RE: Data Responses, Set 2C  
Cosumnes Power Plant (01-AFC-19)

# **COSUMNES POWER PLANT (01-AFC-19)**

## **DATA RESPONSE, SET 2C** (Response to Data Requests: 181, 182 and 183)

**FIGURE HM181-1**  
**AMMONIA SPILL CONTAINMENT**  
 COSUMNES POWER PLANT  
 APPLICATION FOR CERTIFICATION

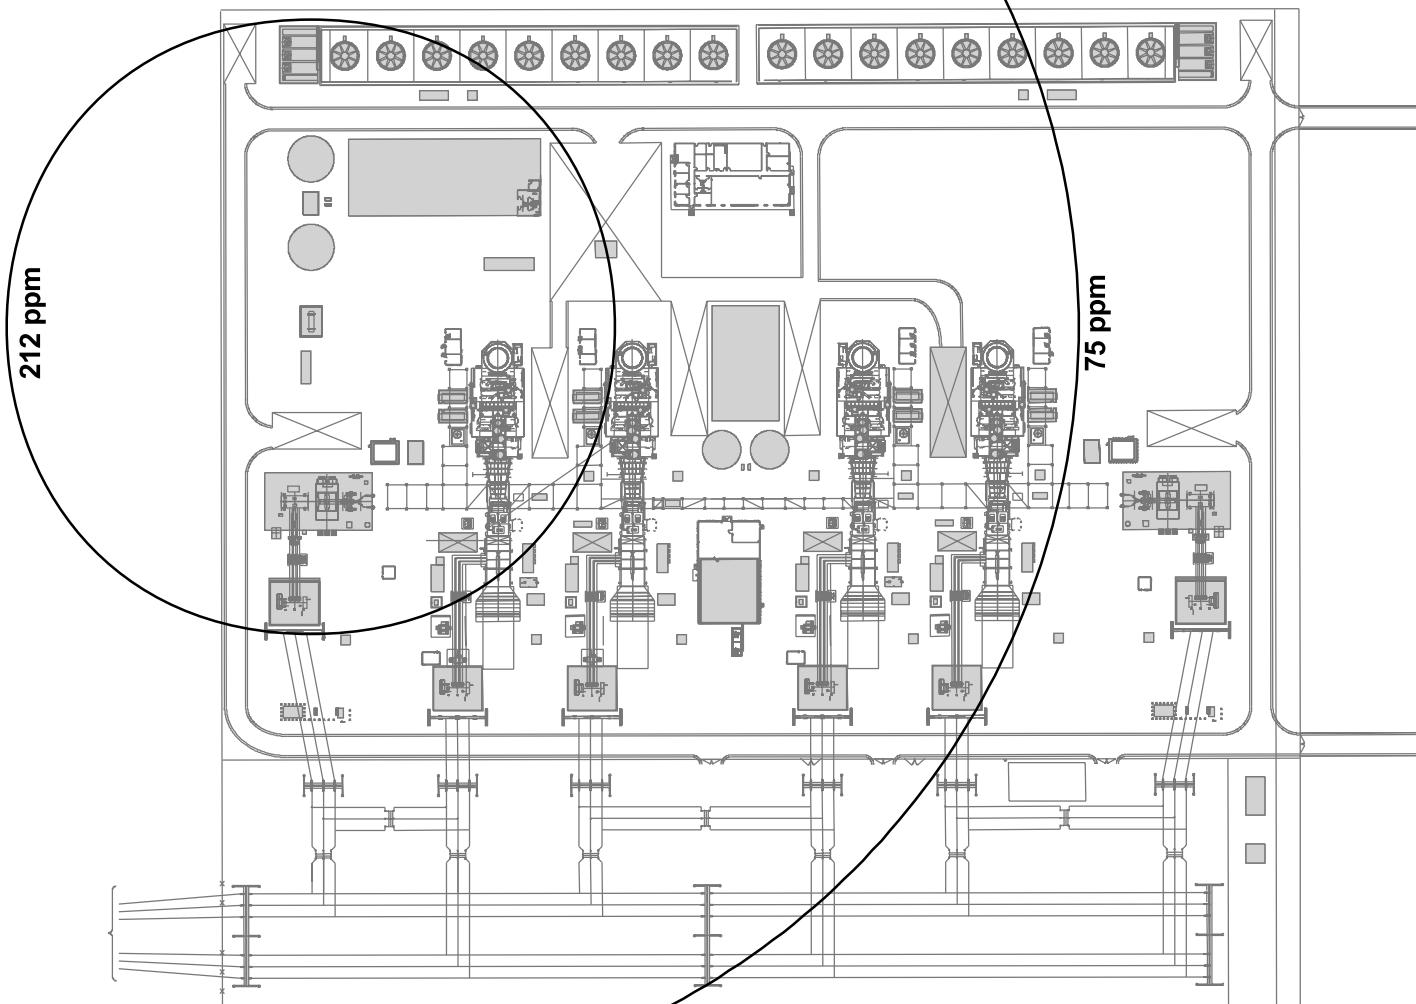
182. Please provide a schematic diagram and narrative describing the proposed catch basin under the aqueous ammonia storage tank and delivery vehicle transfer pad.

**Response:** This response replaces that previously provided in Data Responses, Set 1A. In preparing the OCA analysis, the design of the catch basin/sump was changed from that submitted previously. It is described in Attachment HM-181 and is shown in Figure HM181-1.

CPP will store a 29 percent solution of aqueous ammonia in one stationary storage tank. The tank's capacity will be approximately 18,000 gallons, but will be limited by regulation to storing a maximum amount of 15,000 gallons of aqueous ammonia. The tank will be surrounded by a concrete wall containment berm with a slab that slopes toward a 24-inch diameter drain. The drain will lead into an underground sump sized to contain the entire contents of the tank, plus rain water (see Figure HM181-1).

The aqueous ammonia delivery truck will connect to the stationary storage tank via a 25-foot-long loading hose. The loading hose will have an inside diameter of 2 inches. Similarly, the truck loading area will be located within a bermed area having a sloped pad. The bermed area will drain into the same sump by way of a 10-inch diameter drain that necks down to a properly sized transfer line. Therefore, the total exposed surface area of the containment system, for purposes of the OCA analysis, will be 4 square feet (the approximate area of the 24-inch drain and the 10-inch drain).
